No Practical Alternatives Authorization Certificate

Project Name: Summit Terrace
Project Number: WP-24-119

NO PRACTICAL ALTERNATIVES REVIEW LETTER

Re: **Summit Terrace**
Jordan Buffers No Practical Alternatives Analysis Request
Chatham County, NC
Project No. WP-24-119
SAW-2022-00935
Sage Project #2023.024

JOB NUMBER: 20-113
 CHECKED BY: EDS
 DRAWN BY:
 DATE: AUGUST 2022
 SHEET TITLE: **IMPACT SUMMARY TABLE**
 SHEET NO.: **IE-4.0**

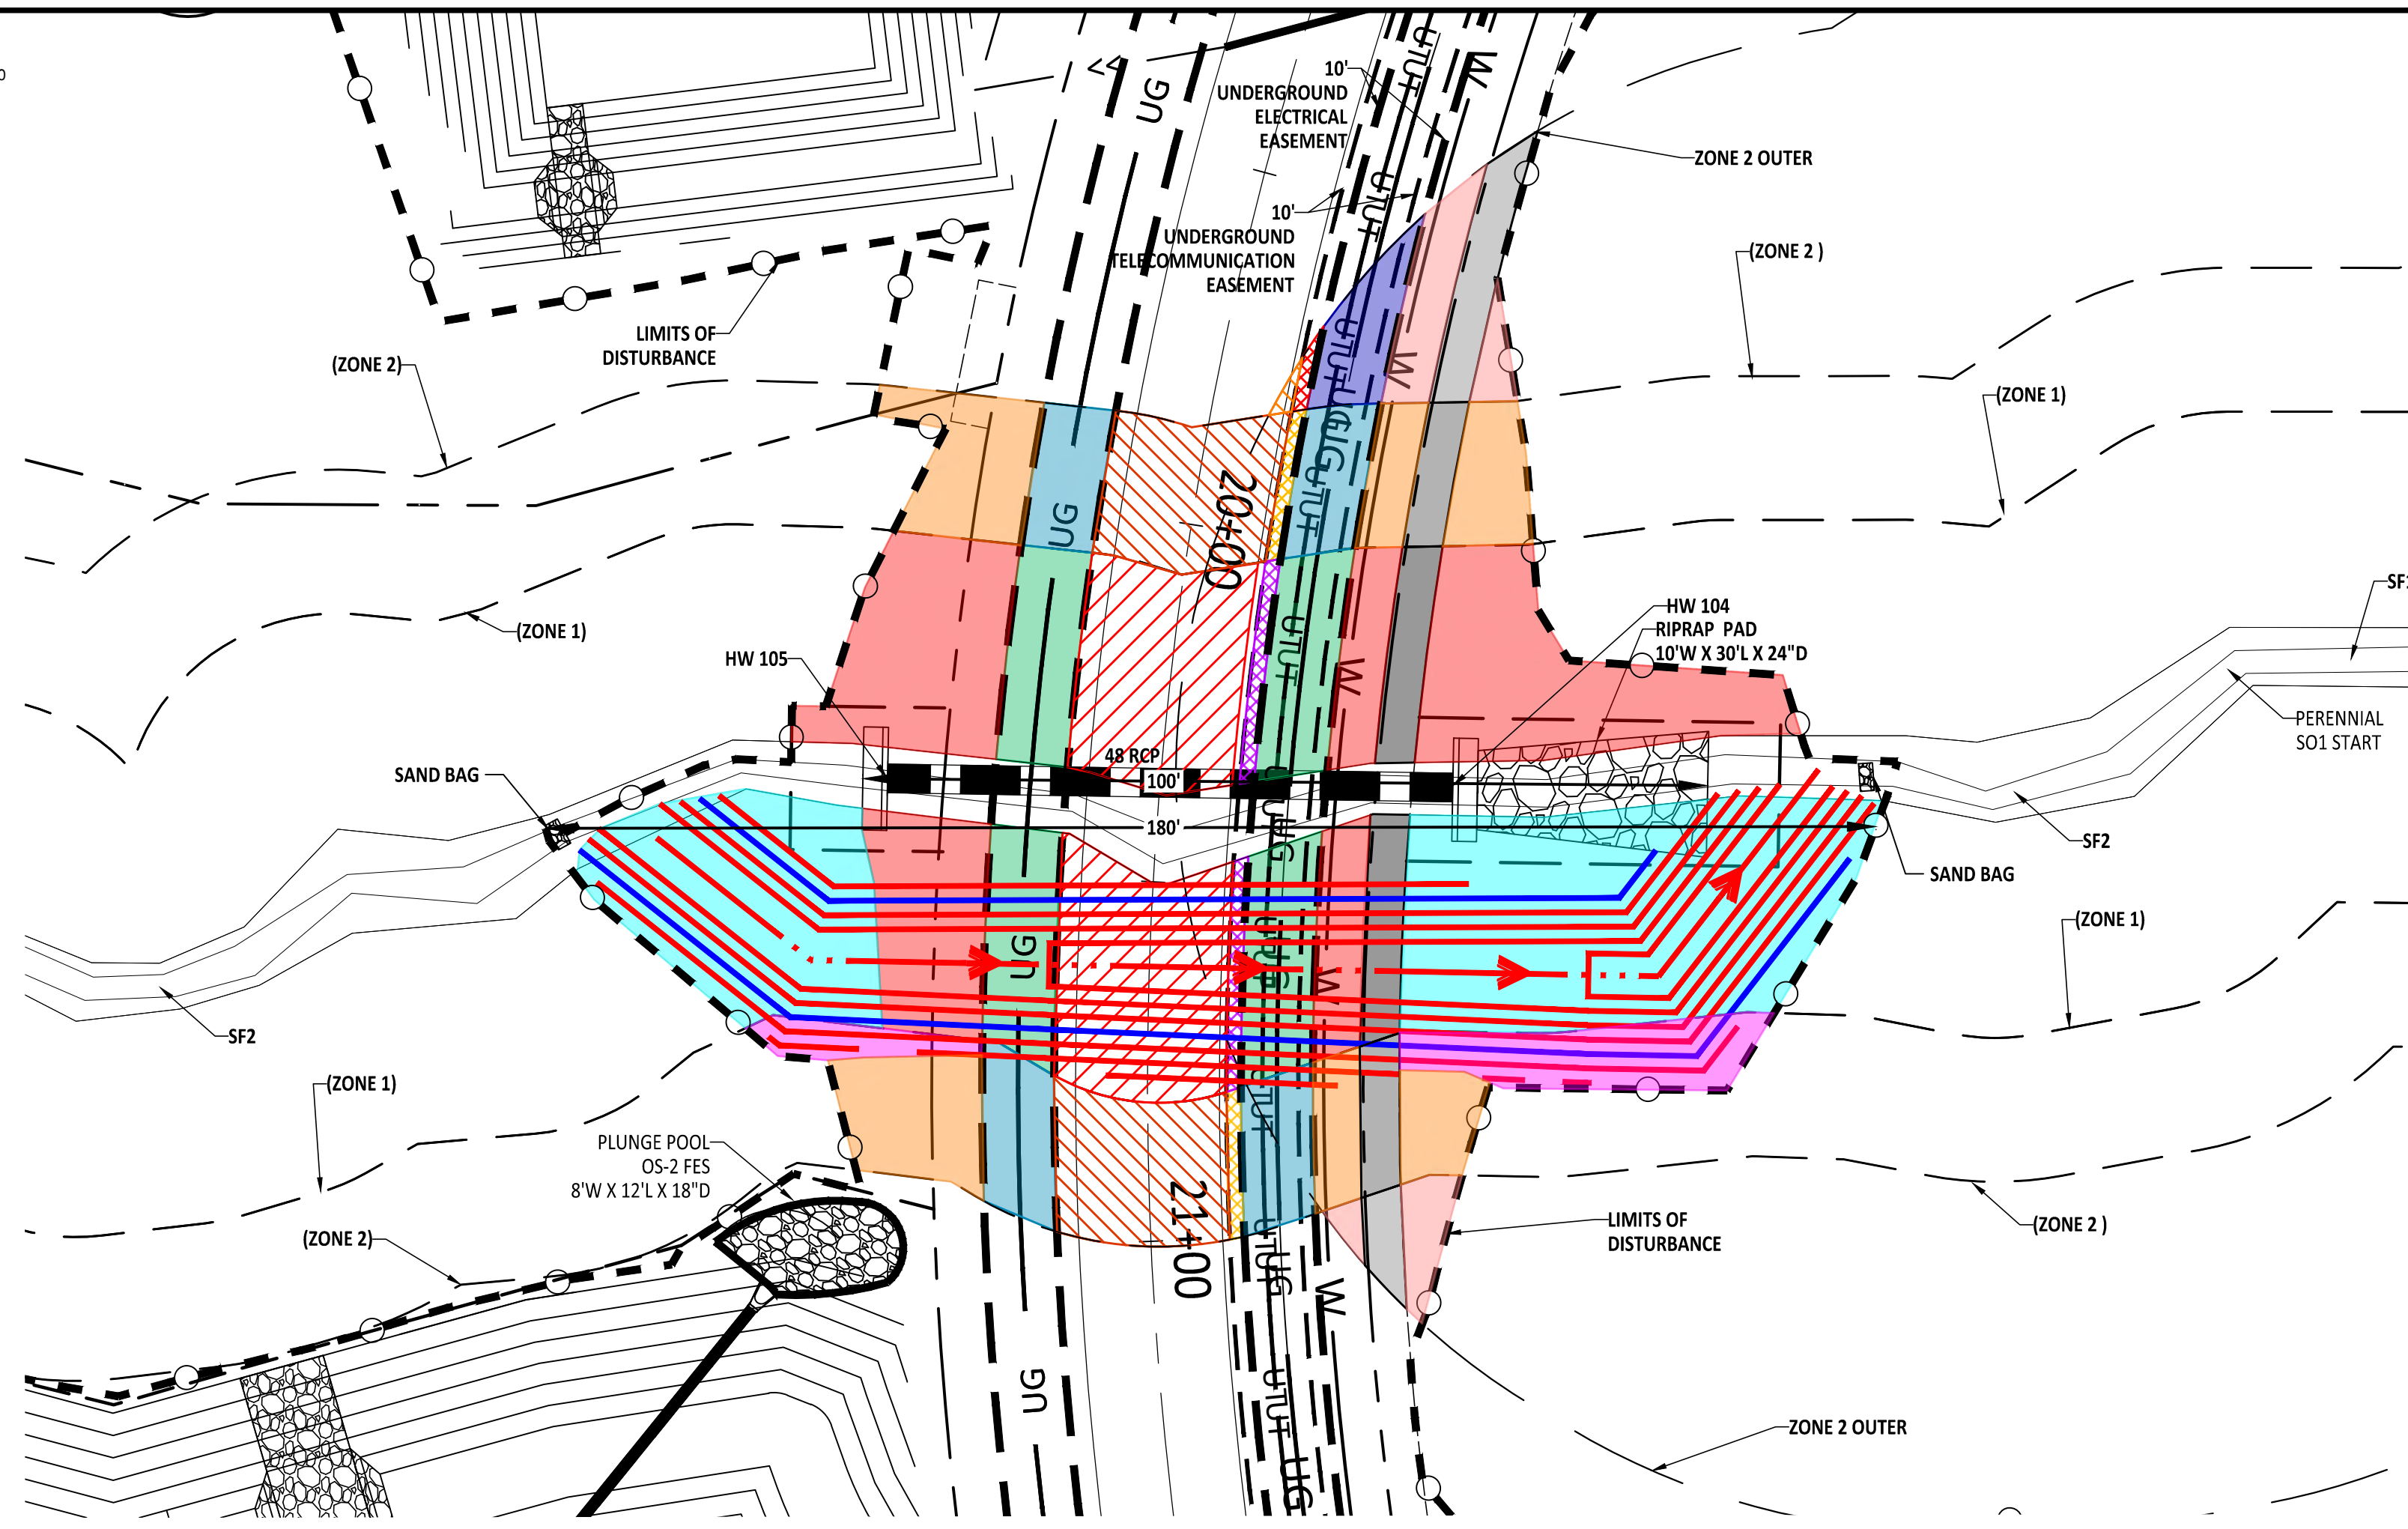
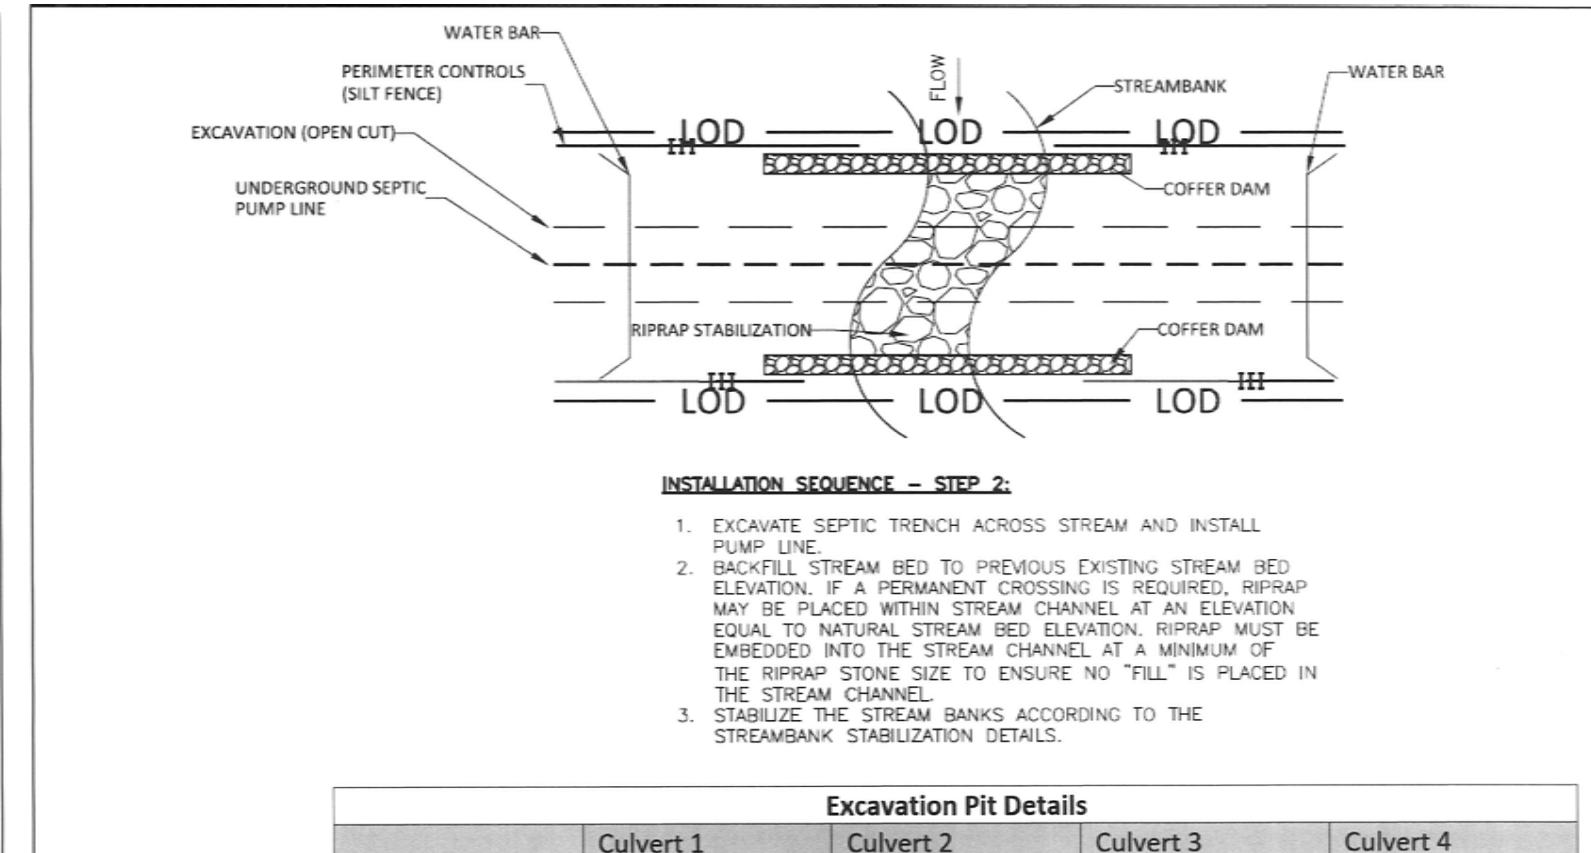
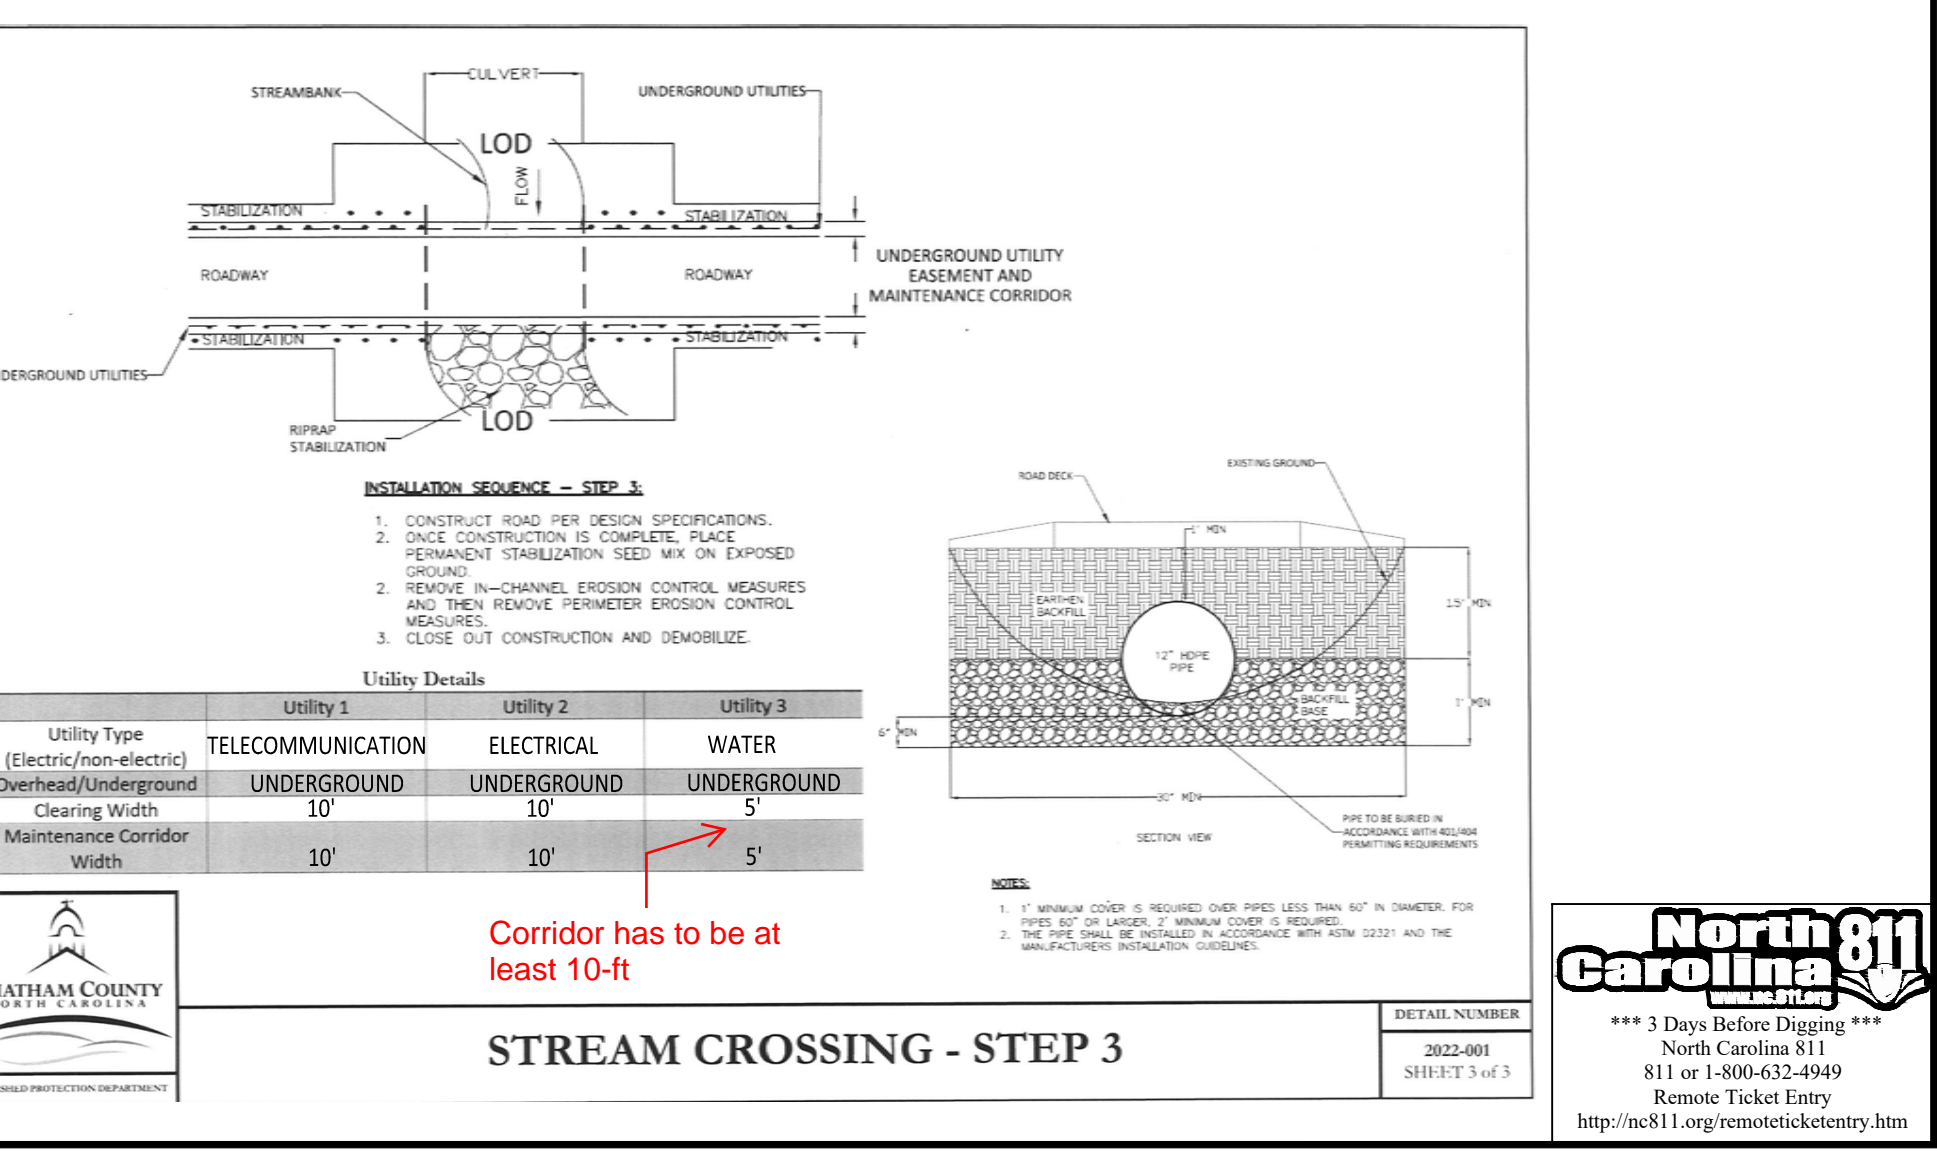
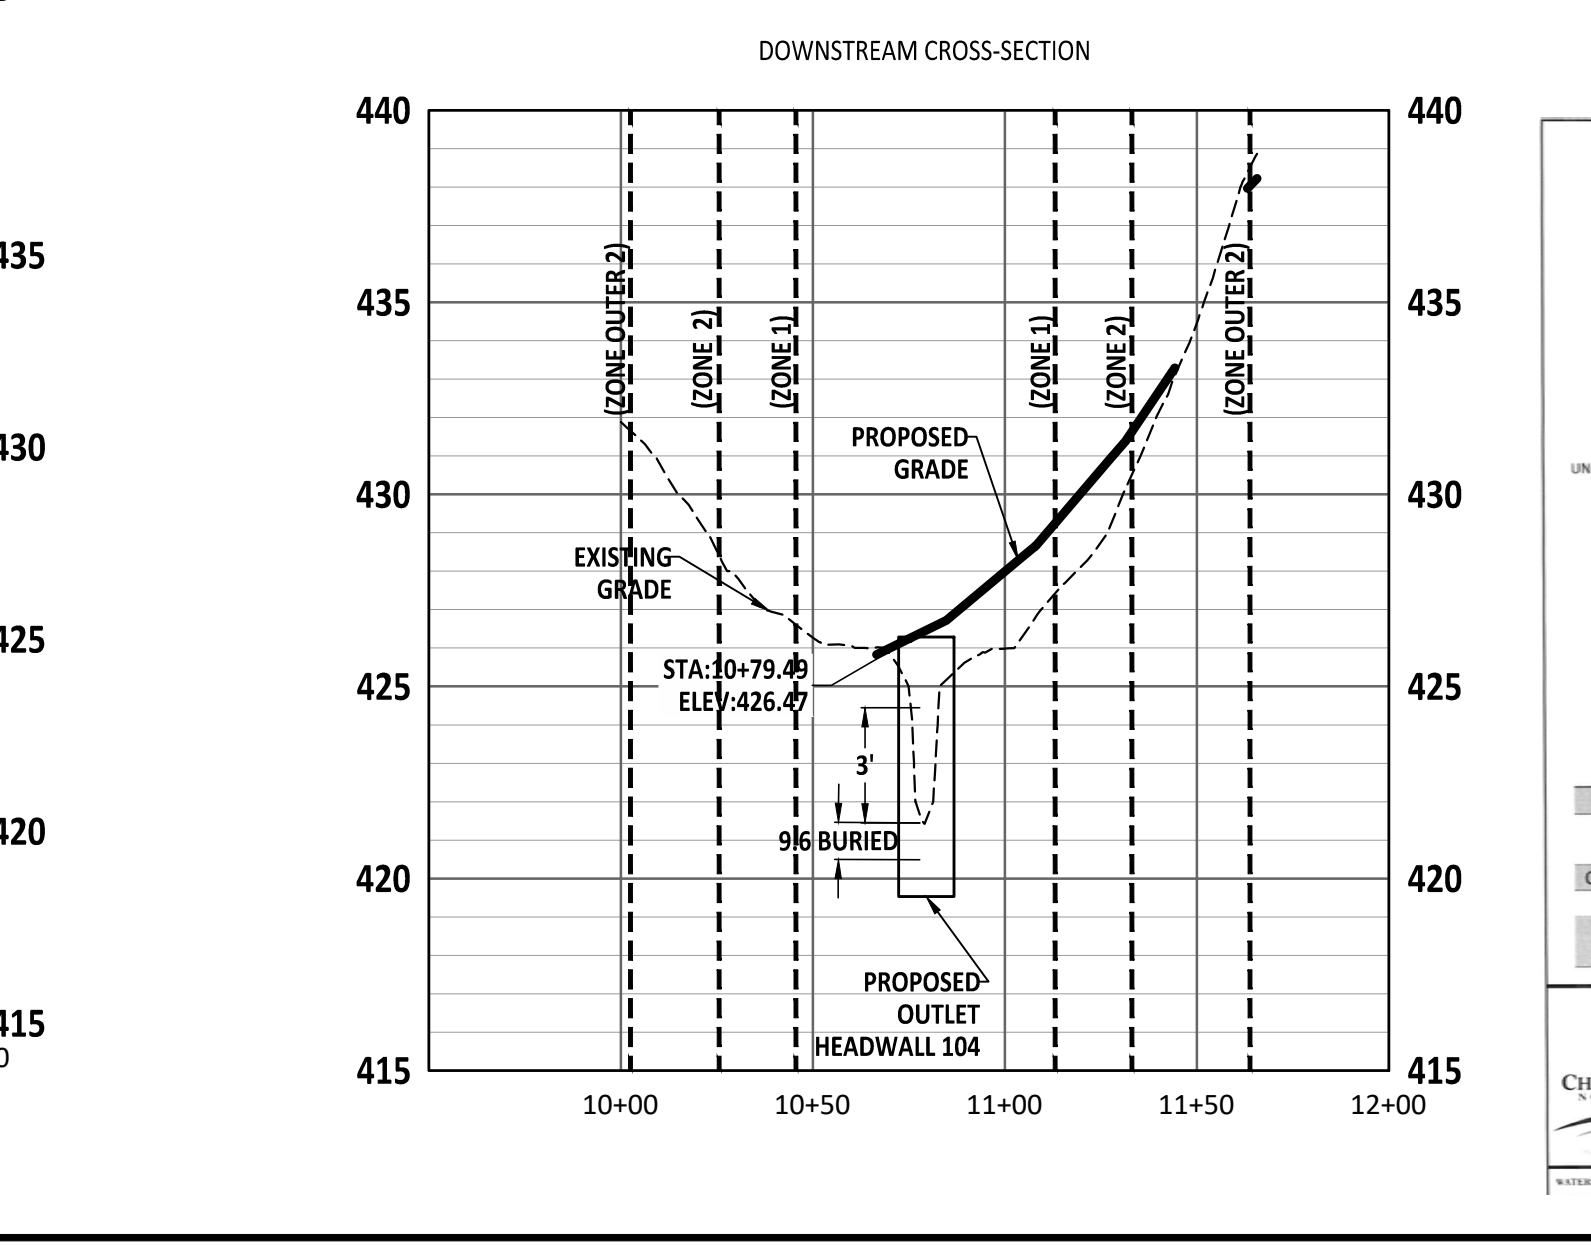
14. Provide documentation to support how utilities will be installed. Each type of utility must be called out on each impact map set, if applicable, and how they will be installed. (bored, open cut, etc.) Additionally, underground electric isn't noted on IE – 4.0, update accordingly.

16. IE – 4.0, Stream Crossing Step 2, does not appear correct. The pipe is 48" within a 14" trench that is only 8" deep. If these values are correct, please justify, if not update accordingly.

17. IE – 4.0, Stream Crossing Step 3 – Utility 1(UG Telecommunication, 20ft), has conflicting values for the maintenance corridor. Step 3 table, buffer impact map set and pipe cross section must match.

A note has been added to the Overall Impact Exhibit (IE-CVR) which explains how the utilities will be installed. Additionally, sheet IE-4.0 shows all the utilities as proposed and includes their respective symbology and description in the legend.

The excavation pit detail width was mistakenly listed as 14-inches. This has been corrected to 14-feet.

The Step 3 table has been corrected and is reflected in the updated impact maps which are attached.
